# Product Change Notice

PCN Number: 16-0626-02  
Issue Date: 22-DECEMBER-2016

Exar Corporation

XR81111-CA04-F | XR81111-CA04TR-F | XR81111-F

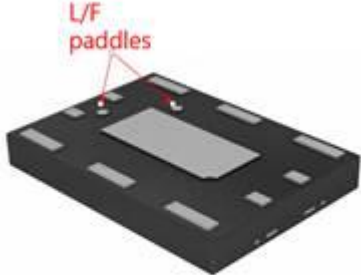
Change in Package 10L QFN lead dimensions, lead position from edge and delete L/F paddle.

10L QFN Package	Change From:	To:

Lead dimension (L2)	0.65mm	1.1mm
Lead Position from Edge	0.16mm	0.1mm
Leadframe paddle	-	Deleted
